**Re: Project, Permit No. M-1980-244;  
Third Adequacy Review, Amendment Application (AM-13) Response to Comments**

## THIRD ADEQUACY REVIEW COMMENTS AND RESPONSES

ATTACHMENT 6  
RESPONSE TO COMMENT C

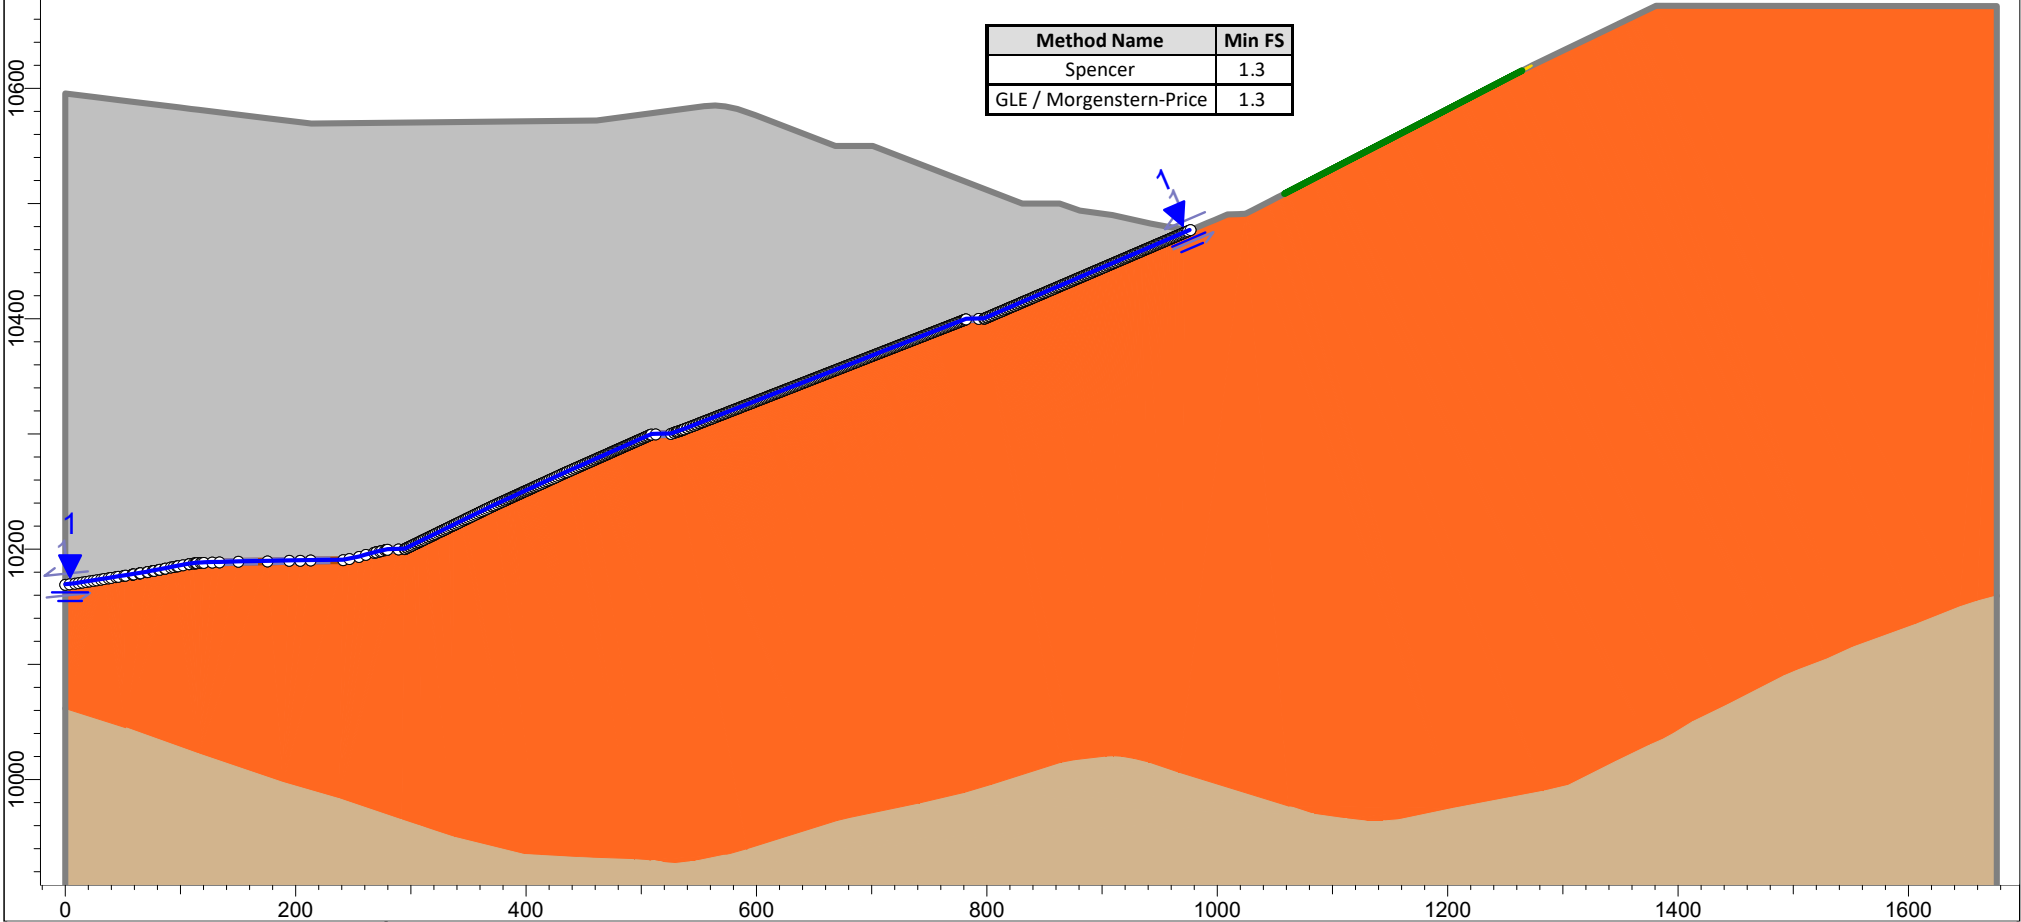
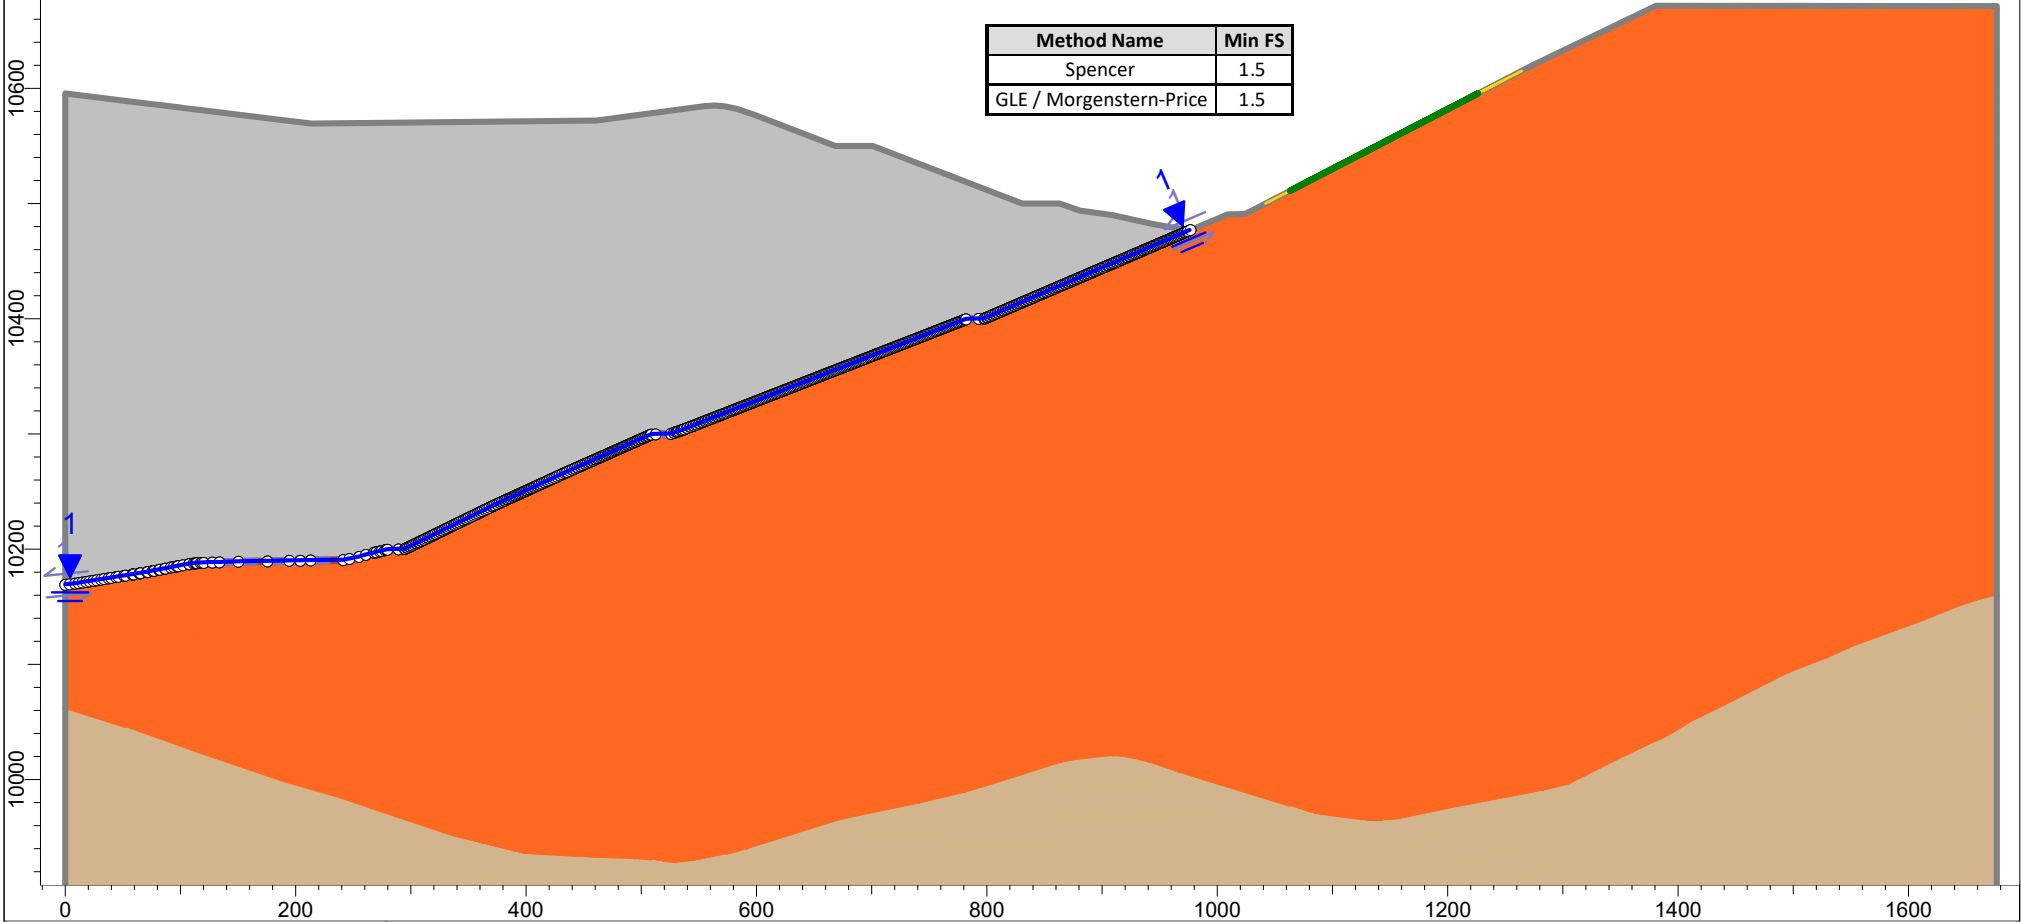
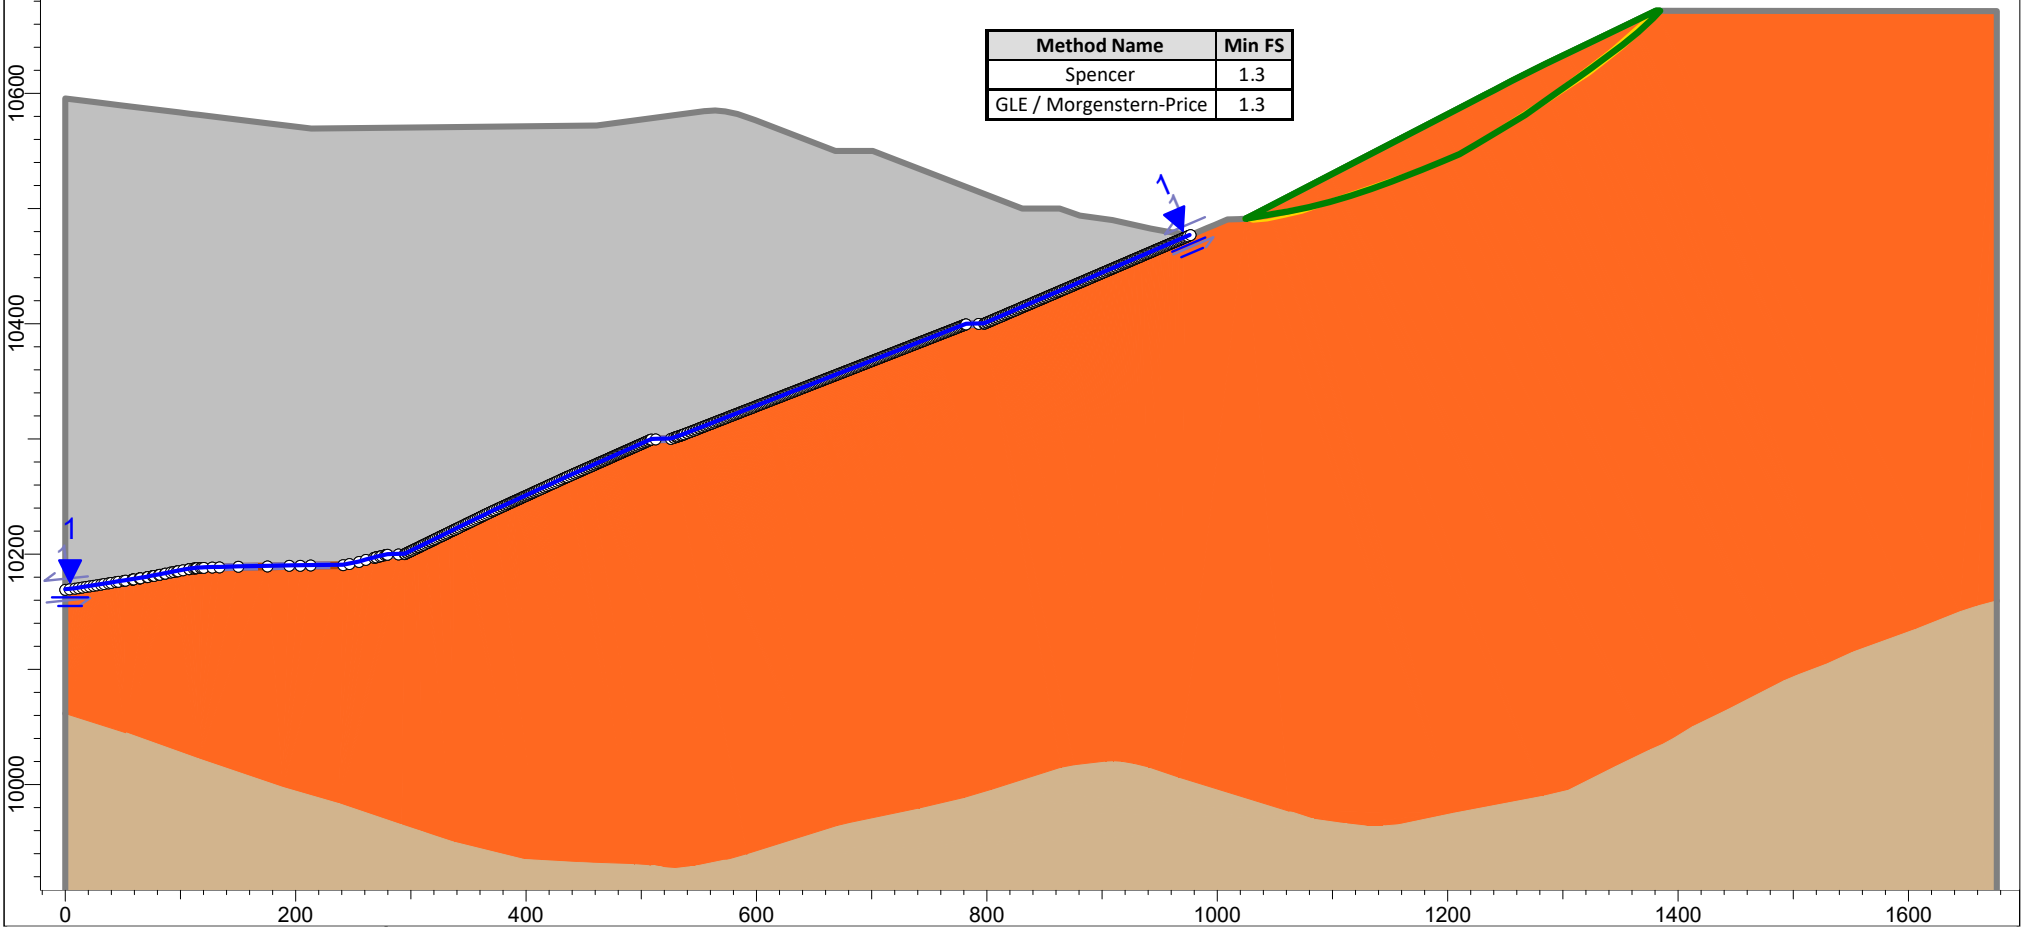
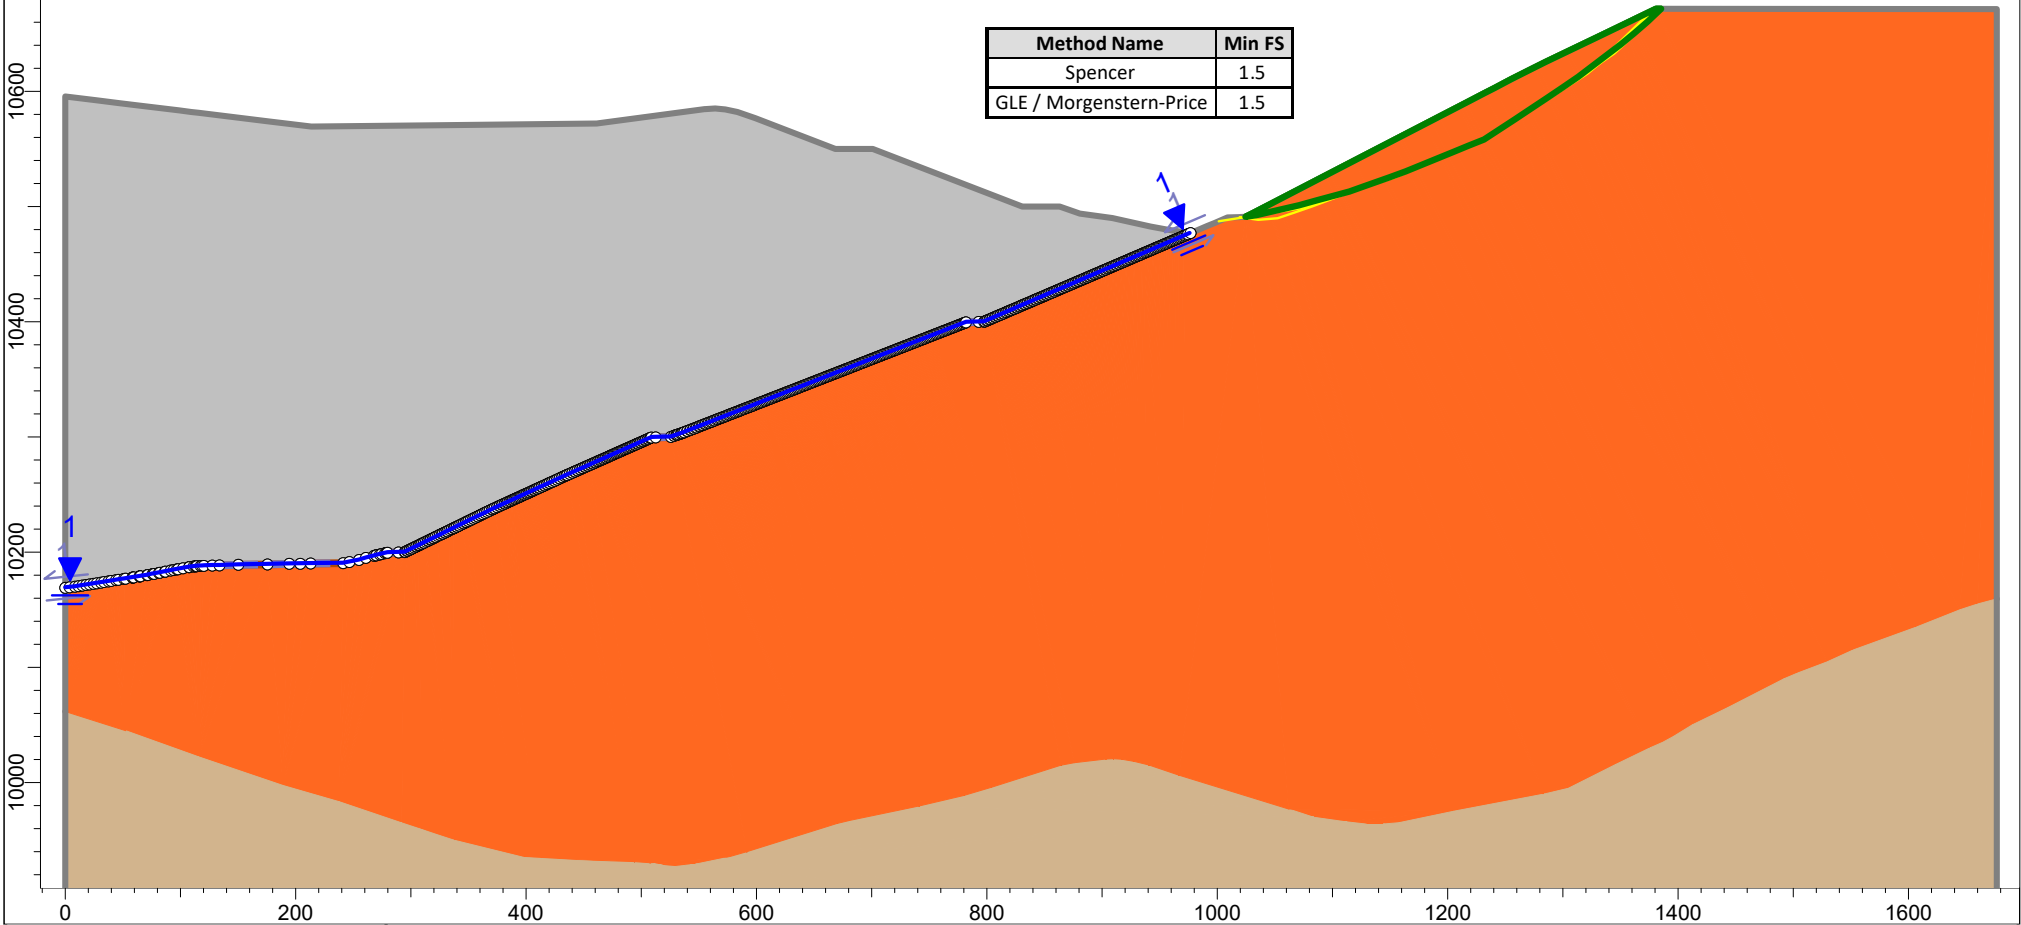
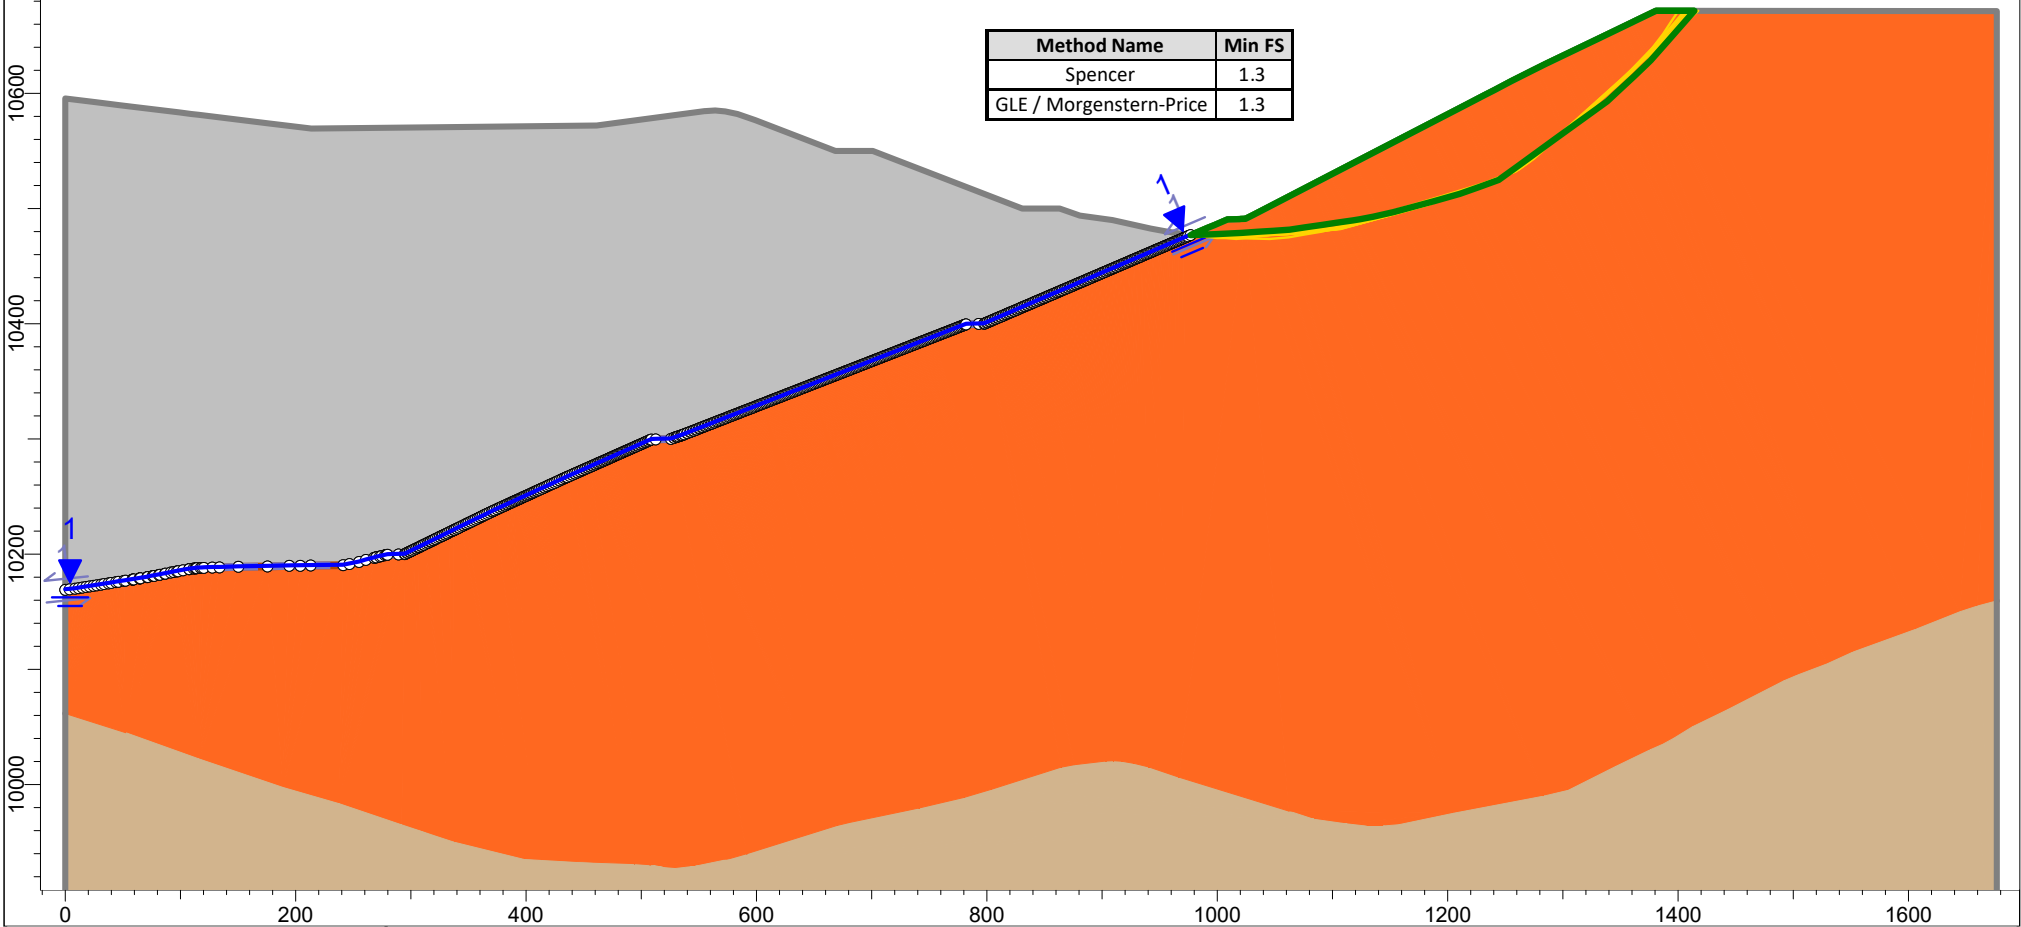
*C. The response requires additional clarification or a revision. The response cites a sensitivity analysis for Section 1 indicating the FoS remains at ~2.015 for all angles of friction analyzed. However, the slope stability analyzed for the north end of Section 1 in the April Preliminary Adequacy Review (PAR) response shows the FoS = 1.4 (see Attachment 1 for Comment C). In addition, all failure surfaces for the north end of Section 1 are in the pit backfill material (see Attachment 1). The same is true for Section 4 in the PAR response. It is implausible that varying the friction angle in Sections 1 or 4 has no effect on the stability. (Note: The DRMS acknowledges the analysis for Sections 2 and 3 support the argument made in the Second Adequacy Review response, as the failure surfaces do not intersect the pit backfill material.) Please explain why varying the friction angle in material for which your analyses demonstrates failure surfaces does not affect the FoS; or revise the designs for Sections 1 and 4 to meet the required FoS (for static conditions  $\geq 1.5$  and for seismic conditions  $\geq 1.3$ ).*

Please refer to CC&V's response to Comment C provided in the previous response to comments. The following is a background summary of A-13 stability evaluations presented:

- ii. The calculated factor of safety was presented as 1.4 and 1.2 for static and pseudostatic conditions, respectively.
- 2) The revised design report (NewFields, July 2020, Rev. 1): Presented a stability analysis for Section 1 and adding in an evaluation of Section 4, enclosed as Attachment 6.

- 3) The responses provided to DRMS in the November 2020 PAR included additional stability evaluations.
  - a) Section 1 stability evaluation was modified to force the failure surface through the VLF and not along the underlying Schist Island Pit backfill. The SLIDE model output results for Section 1 and the new critical failure surface are provided in Attachment 6.

failure surface presented in the Design Report (Rev. 0 and Rev. 1) were not significant enough to compromise the integrity of the VLF liner system or overall stability. In general, the presented failure surface along the backfill slopes are veneer failures that are: (1) a function of how the shear strength is modeled using the Mohr-Coulomb failure envelope, and (2) generally veneer failures are operational concerns and not indicative of global instability. The revised Phase 1 stability evaluation is considered more appropriate to assess true global slope stability, and indicates that this section of the facility is quite safe. The calculated factor of safety was presented as 2.0 and 1.7 for static and pseudostatic conditions, respectively.

- b) The new critical failure surface identified for Section 1 was then evaluated using a sensitivity analysis, which was provided in the text of the response to Adequacy review Comment C in the November 2020 submittal. The results of that sensitivity analysis, a plot of Factor of Safety v. Friction Angle, is also provided in Attachment 6.

- c) Section 4 stability evaluation is identical to the Revision 1 submittal (NewFields, July 2020).
- 4) In conclusion:
- a) Global stability of Section 1 is acceptable because the global stability analyses performed have been updated to (i) screen out results that reflect how the model uses the failure envelope (as mentioned above, and discussed in detail below) and (ii) screen out results associated with general veneer failures that are not indicative of global stability. The calculated factors of safety for the stability analyses are 2.0 and 1.7 for static and pseudostatic conditions, respectively.

- b) Veneer style failures of the Schist Island Pit Backfill (e.g. below VLF2 Phase 3 in Section 1) or the regraded SGOSA slopes (e.g. above VLF3 Phase 3 in Section 4) are primarily a function of how we model shear strength of these materials with Mohr-Coulomb failure criteria ( $\tau = \sigma_n \cdot \tan\phi + c$ ). If we model these materials as purely friction (i.e. cohesion is zero), then the shear strength ( $\tau$ ) is only a function of the normal stress ( $\sigma_n$ ) along the potential failure plane. Very thin failure planes, such as the veneer failures, have very little normal stress along the potential failure plane and thus the modeled shear strength is very low. This tends to drive the factor of safety down and geotechnical software will calculate this as the lowest factor of safety. This phenomena is generally controlled by the evaluating engineer using judgement on what constitutes significant slope movement that can compromise containment or global stability.
